DAVE'S FIRST ADDITION SUBDIVISION

APPLICATION NUMBER 12 DATE May 1, 2008

REQUEST Subdivision

DETAIL SITE PLAN

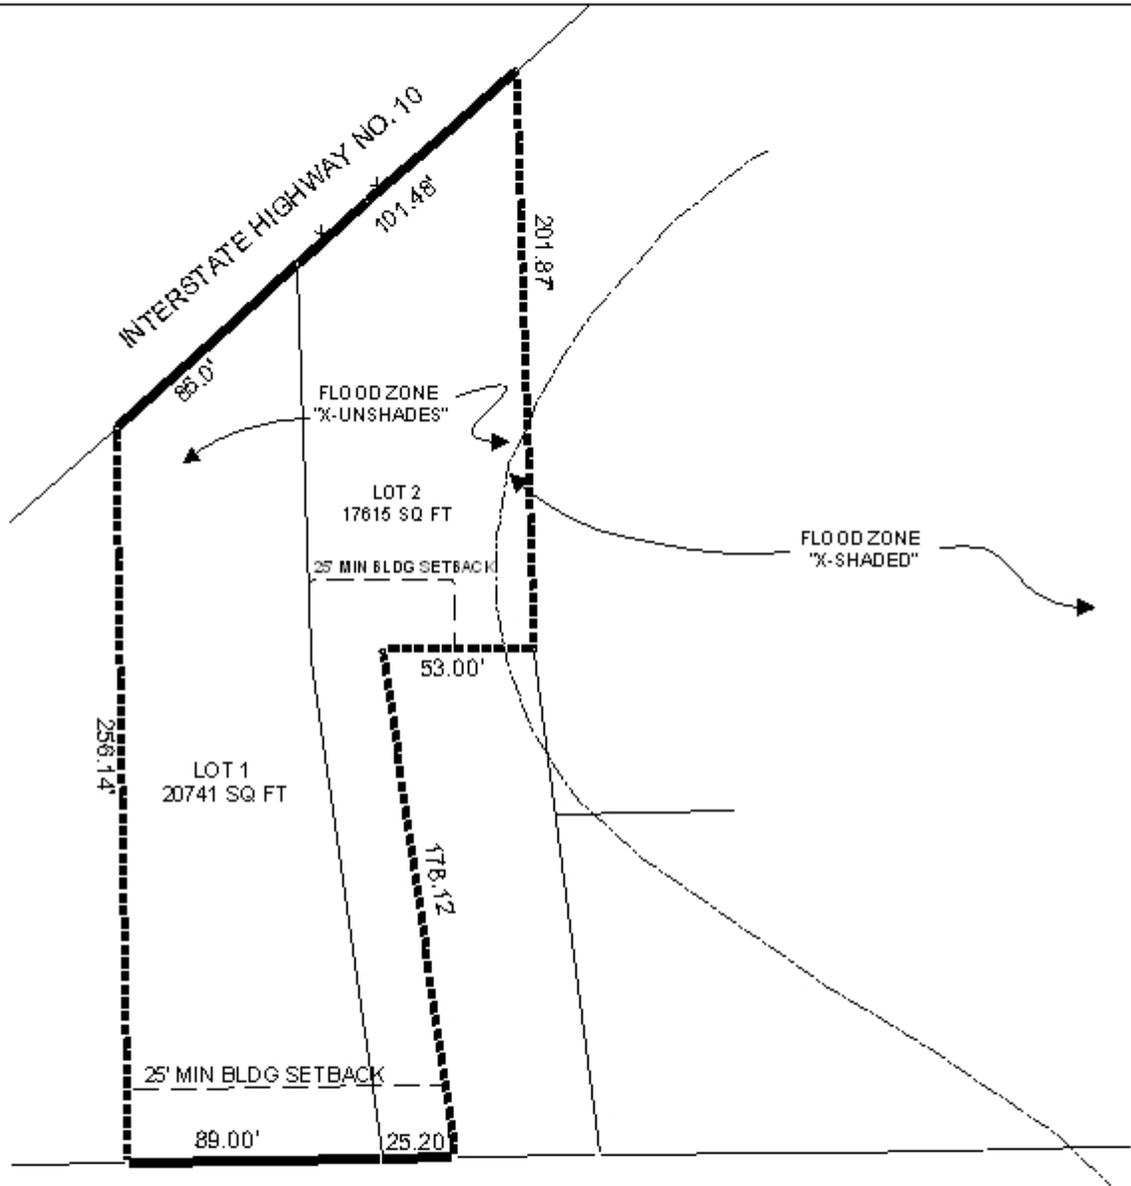
Both lots would have frontage on Lloyds Station Road with a compliant 60' right-of-way, therefore, no dedication would be required. As a means of access management, a note should be

required on the final plat stating that each lot is limited to one curb cut to Lloyd Station Road, with the size, location, and design to be approved by Traffic Engineering and conform to AASHTO standards. Since both lots have rear frontage on Interstate 10, a note should be required on the final plat stating that access to Interstate 10 is denied.

The 25' minimum building setback line is shown on the plat along Lloyd Station Road for both proposed lots. This should also be shown on the final plat as it is on Lot 1, but should be removed for Lot 2 and only illustrated as it is "boxed" from the point where the "pole" meets the lot, providing 25' clear in all directions from that point.

Each lot is labeled on the plat with its size in square feet. This should be revised on the final plat so that each lot is labeled with its size in acres and square feet, or a table should be provided furnishing the same information.

- 1) placement of a note on the Final Plat stating that each lot is limited to one curb cut to Lloyd Station Road, with the size, location, and design to be approved by Traffic Engineering and conform to AASHTO standards;

- 2) placement of a note on the Final Plat stating that both lots are denied access to Interstate 10;
- 3) illustration of the 25' building setback line along the road frontage of Lot 1;

- 4) illustration of the 25' building setback line for Lot 2 "boxed" from the point where the "pole" meets the lot, providing 25' clear in all directions from that point;

- 5) labeling of each lot with its size in acres and square feet, or the provision of a table on the plat furnishing the same information; and
- 6) placement of a note on the Final Plat stating that development of this site must be undertaken in compliance with all local, state and Federal regulations regarding endangered, threatened or otherwise protected species; and
